Application for Variation of an Environmental Permit

No previous application for variation of an environmental permit.
 The environmental permit was previously amended.
Application No. : VEP-132/2004

PROPOSED PUBLIC HOUSING DEVELOPMENT AT KAM
SHEUNG ROAD SITE 4A - ASSESSMENTS FOR
SUPPORTING VARIATION OF ENVIRONMENTAL PERMIT
(VEP) APPLICATION)

ENVIRONMENTAL REVIEW REPORT

Drawing title
**LOCATION OF EXISTING NOISE BARRIER ALONG TUNG
 WUI ROAD**

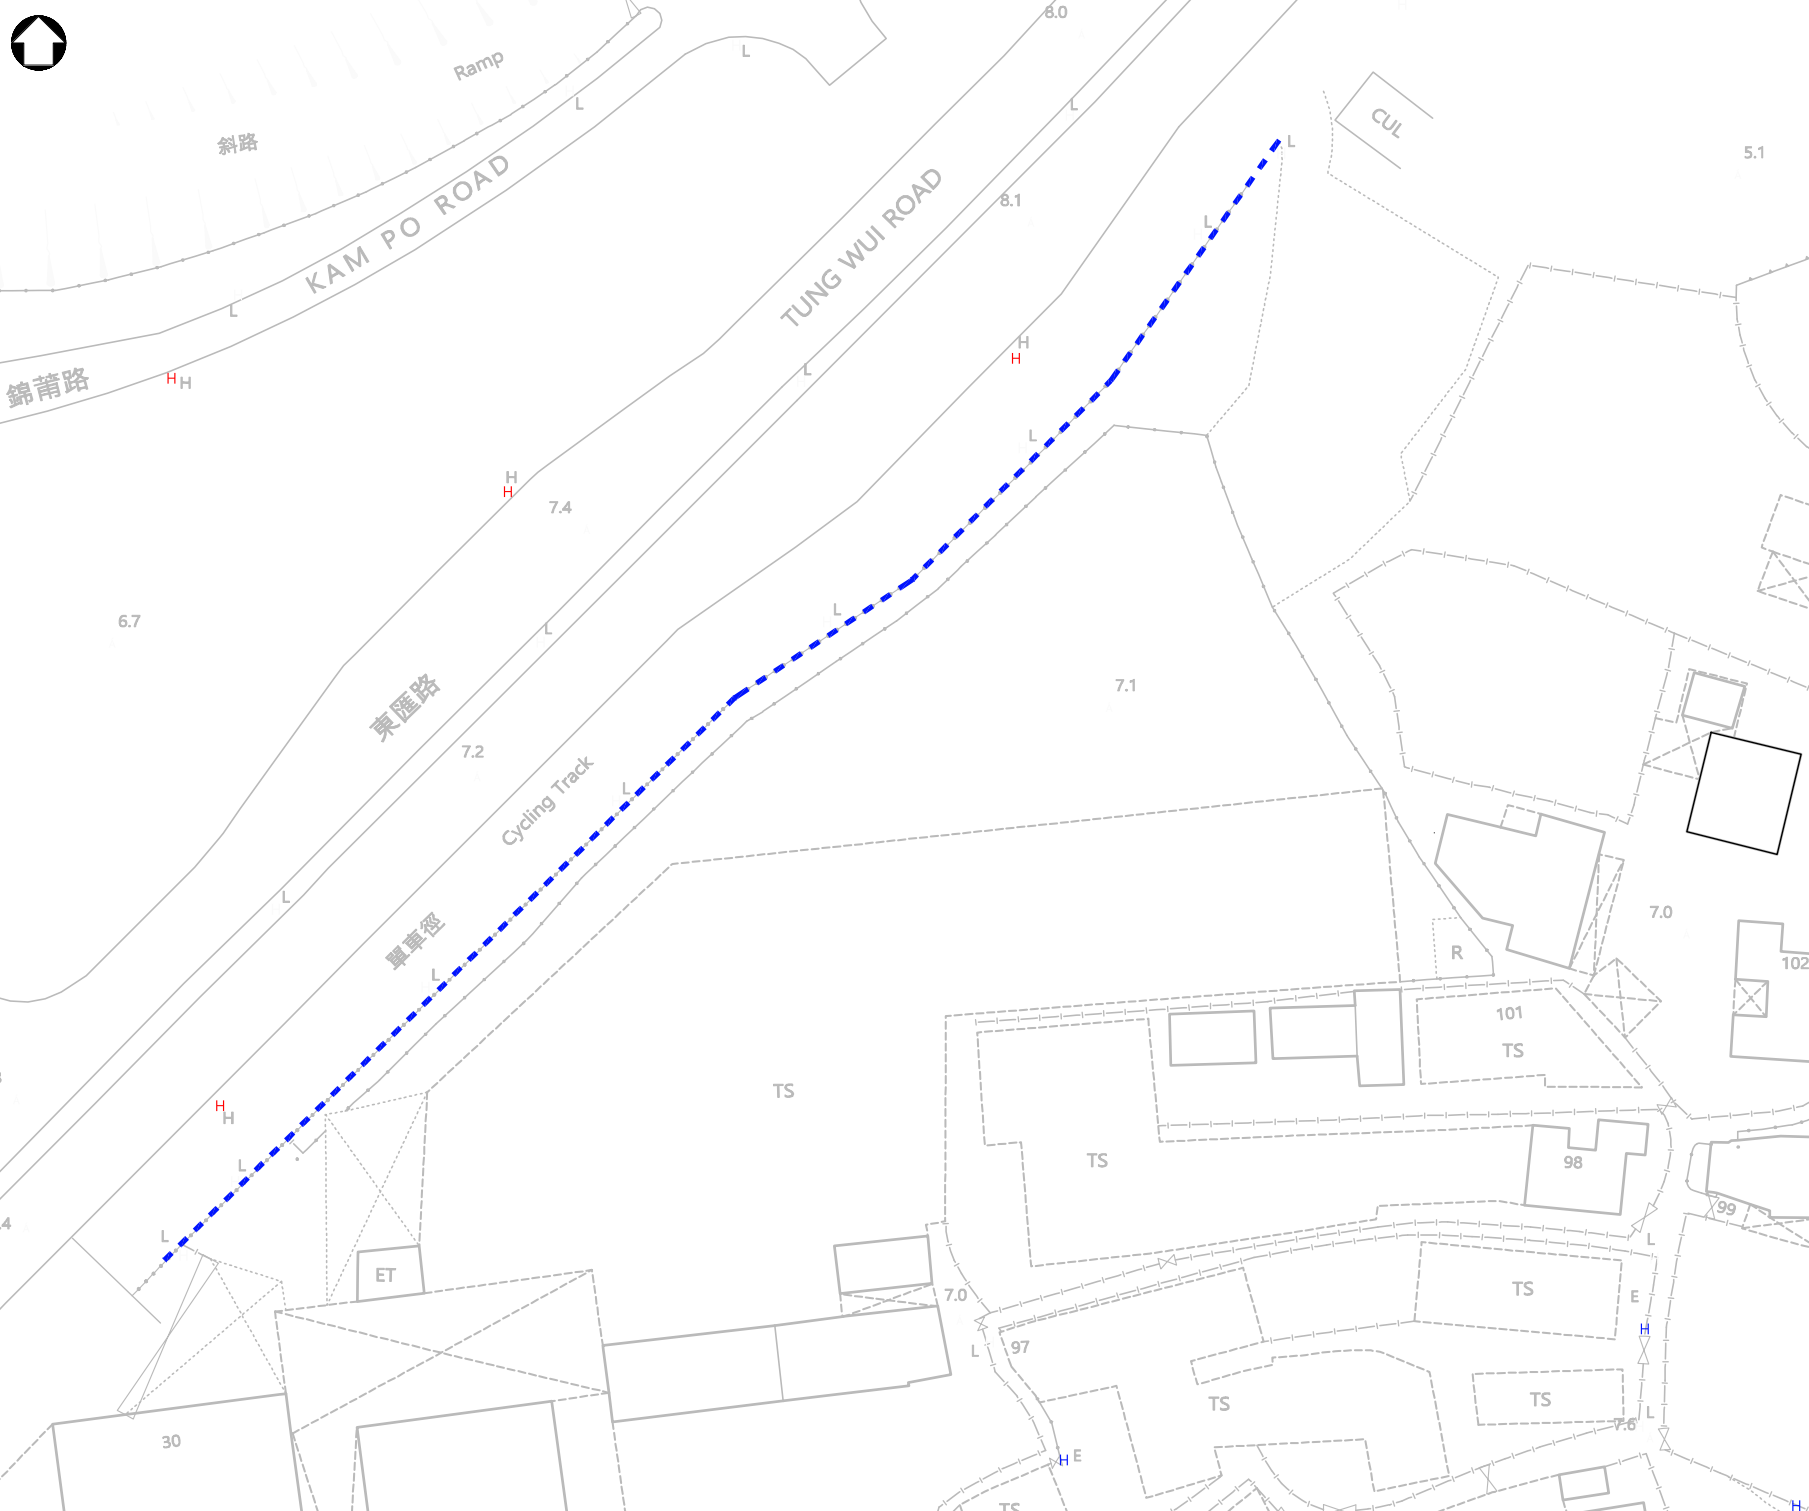
- 1.1.3 In the approved EIA report (Registered No. AEIAR-025/1999), a 5.5 m high, 150 m long noise barrier (hereafter “the concerned noise barrier”) is located next to the bus-bay and behind the footpath along the south bound carriageway of the Tung Wui Road (previously named as Eastern Access Road), has been proposed as a road traffic noise mitigation measure (see **Figure 1.1**).

- 1.1.5 As such, the concerned noise barrier is proposed to be demolished for these reasons: (1) to improve the development potential, public accessibility and convenience in the local area; and (2) the noise screening function for existing NSR87 by the concerned noise barrier could be provided by the building blocks of the proposed housing development as demonstrated in Section 3.

2.1(h)	The Permit Holder shall provide a 5.5 m high, 150 m long noise barrier next to the bus-bay and behind the footpath along the south bound carriageway of the Eastern Access Road, south of the Eastern Access Road/Kam Sheung Road junction.	The concerned noise barrier is proposed to be demolished in 2024. Hence, Condition 2.1(h) is proposed to be deleted from the EP.

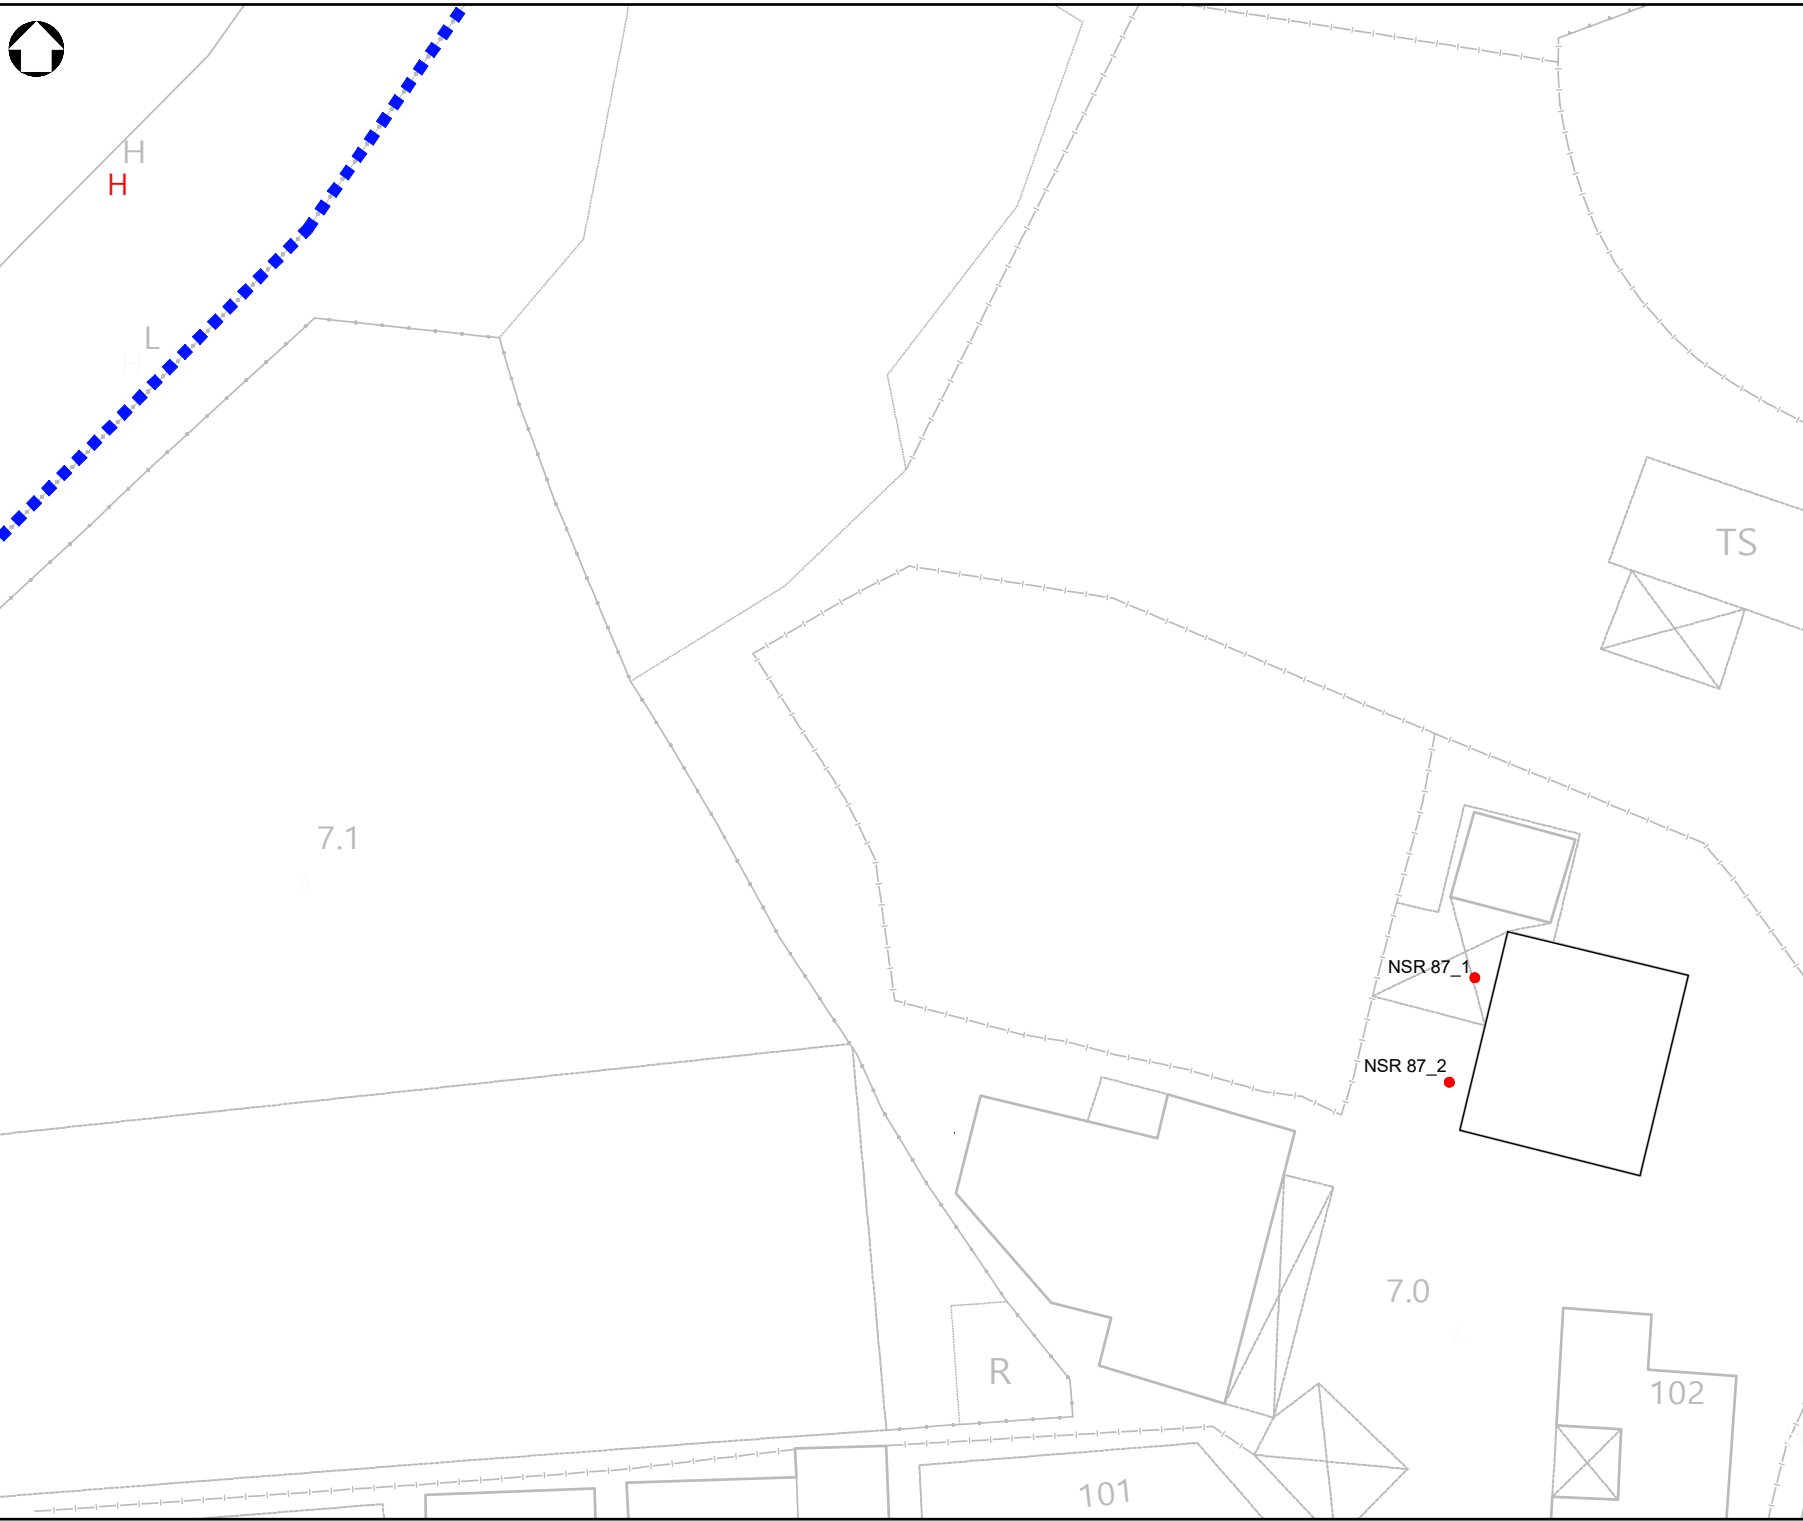
Figure No.	Figure Title	Proposed Change
Figure 1	Location of the Project	No change
Figure 2	Direct Road Traffic Noise Mitigation Measures for Kam Tin Eastern Access Road (North & East Section)	No change
Figure 3	Direct Road Traffic Noise Mitigation Measures for Kam Tin Eastern Access Road (South & West Section)	Figure 3 of the existing EP is proposed to be replaced by Figure 2.1 of this report.
